Project Name: Madison County Schools - Madison Central Press Box Improvements

Project Number: 25-053

ADDENDUM NO. 01

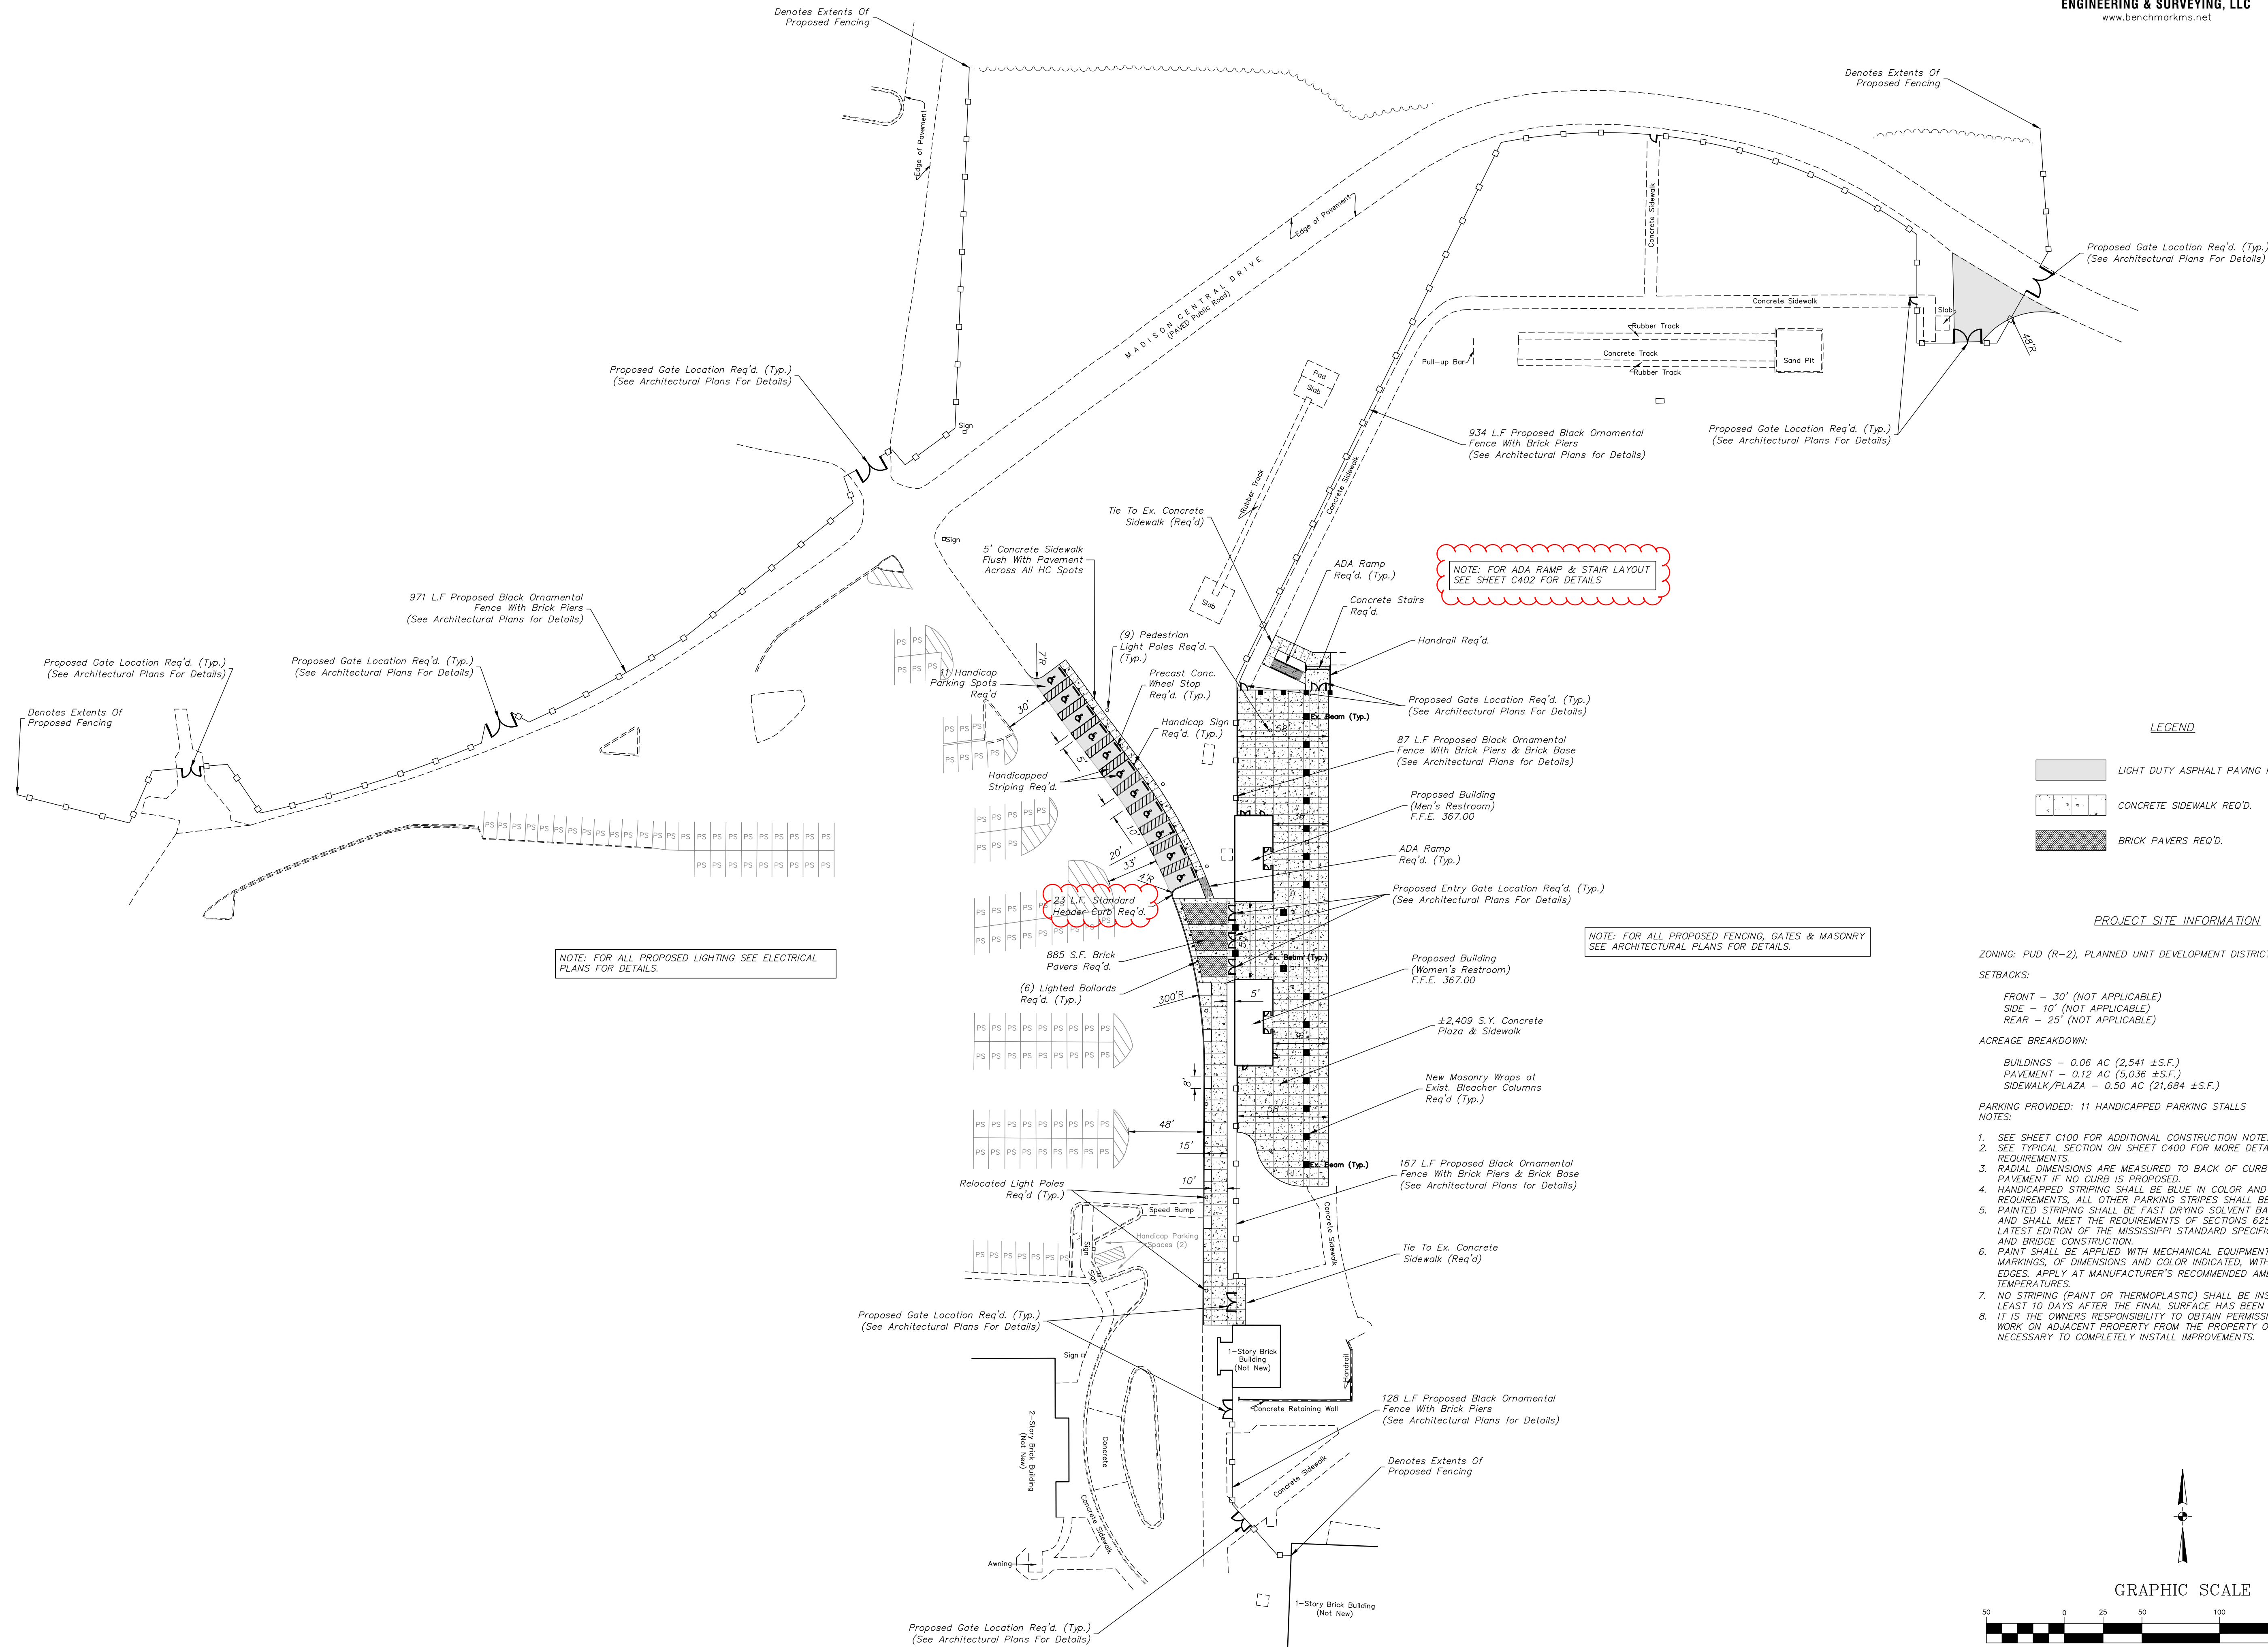
- ITEM NO. 13 **C200 DEMOLITION PLAN**
REVISION: Updated the extents of existing concrete removal.
- ITEM NO. 14 **C201 SITE PLAN**
CLARIFICATION on length of curb and ADA reamp reference.

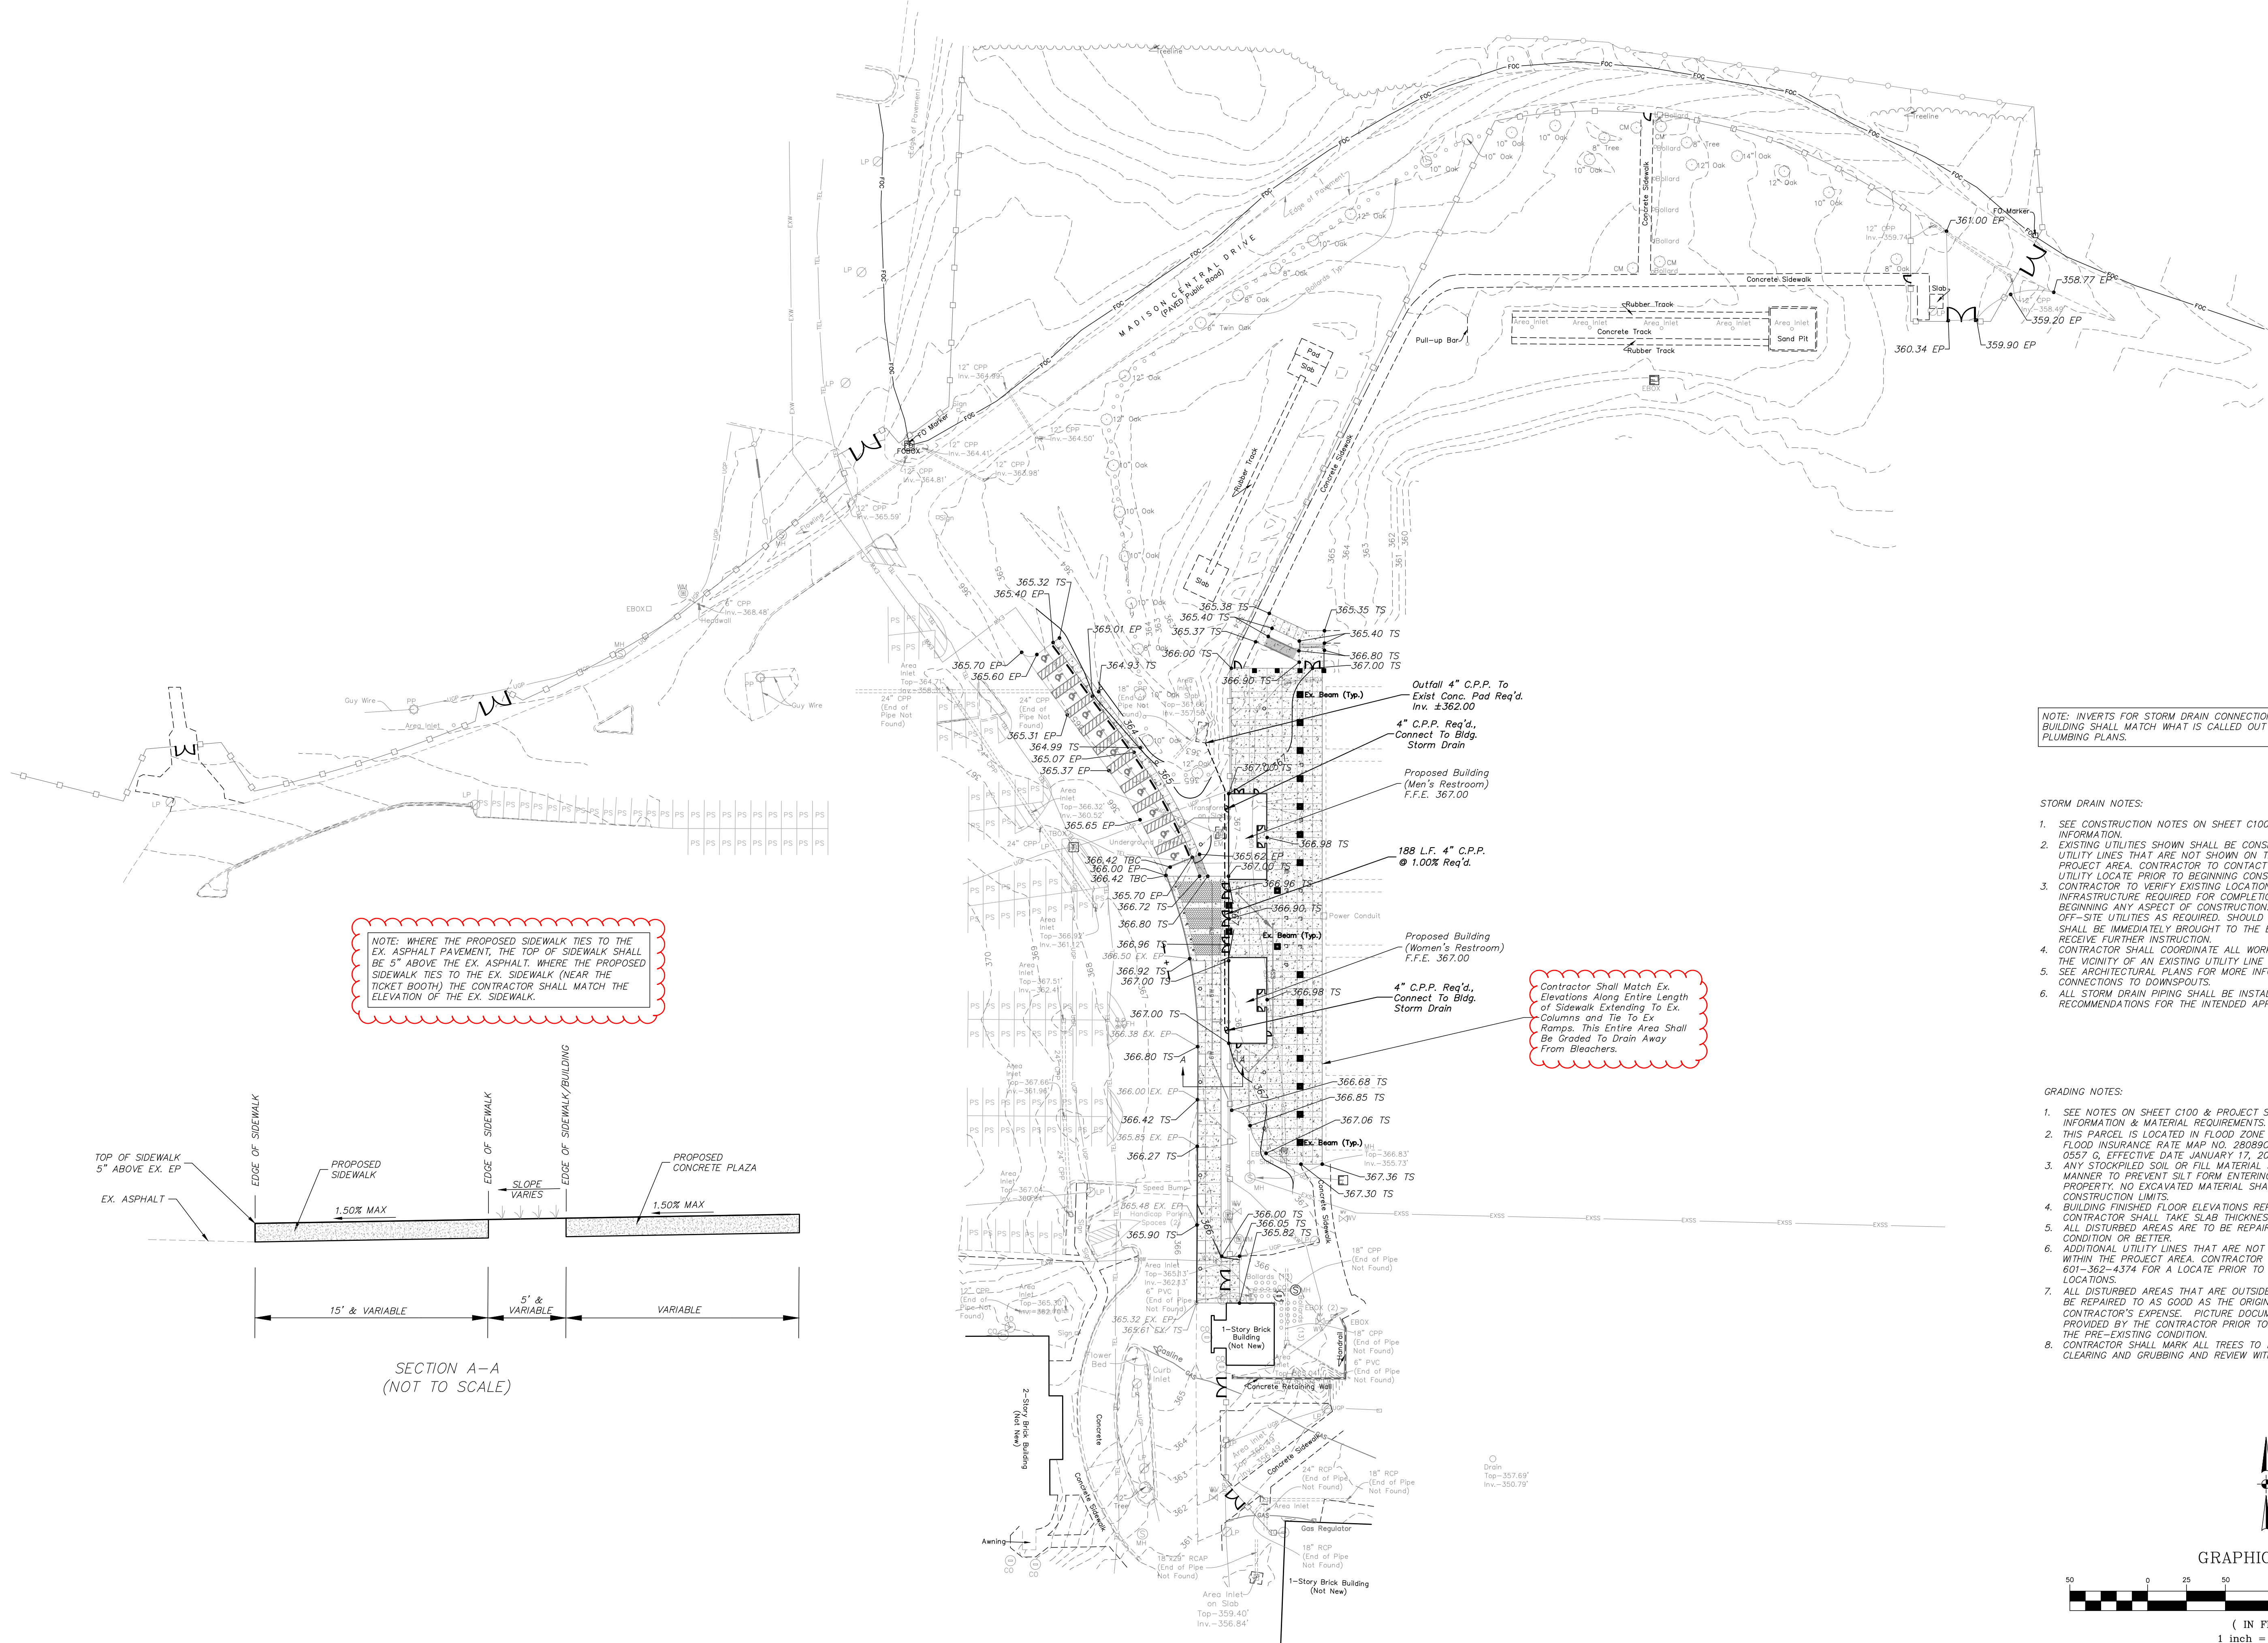
- ITEM NO. 15 **C300 GRADING & DRAINAGE PLAN**
CLARIFICATION on tying new pavements into existing.
- ITEM NO. 16 **C302 LANDSCAPING PLAN**
ADD Sheet A302.
